Determination 2022/019

Regarding the authority's refusal to issue a code compliance certificate for the stucco monolithic plaster cladding on an extension to an existing dwelling

468A Wright Road, Aongatete, Katikati, Bay of Plenty

Figure 1(b) – Flashing for timber window frames

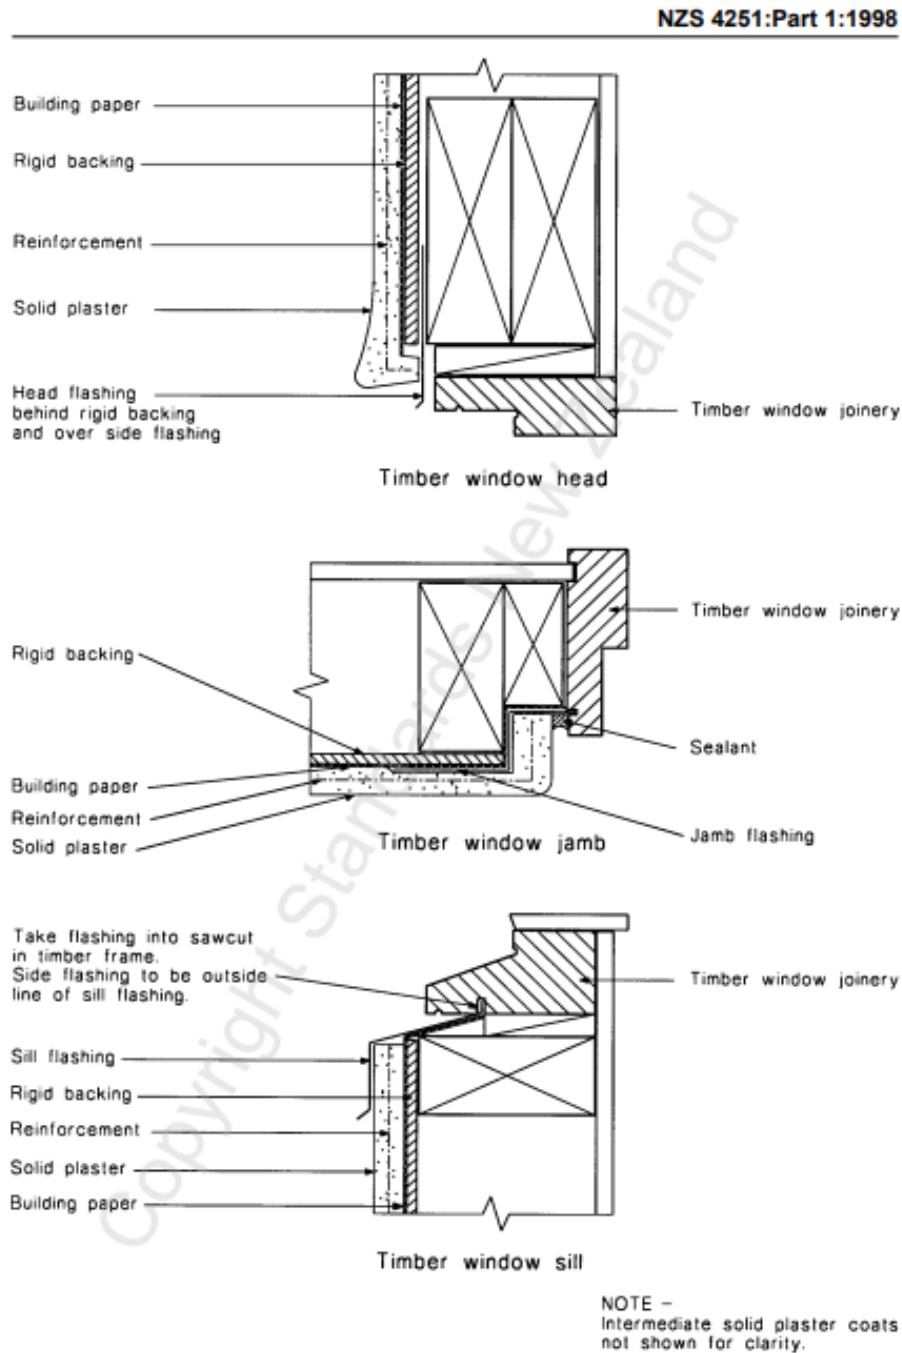
5.6. The expert noted that NZS 4251.1:1998 figure 1(b) provided head, jamb and sill flashings details (see Appendix B)²⁰, but no flashing details were included in NZS 4251:1974.

5.13. The expert noted that NZS 4251.1:1998 provides “a concealed jamb flashing detail for timber windows”, and the Good Stucco Practice shows three concealed jamb flashing details for aluminium windows.

No visible jamb flashings are installed. It could not be confirmed from on-site observations that there are no jamb flashings installed (but if concealed flashings are installed, they do not drain to the exterior).

The as built jamb junctions do not appear to comply with either the NZS 4251.1:1998 or BRANZ [Good Stucco Practice] details but look reasonably well sealed and appear to be performing.
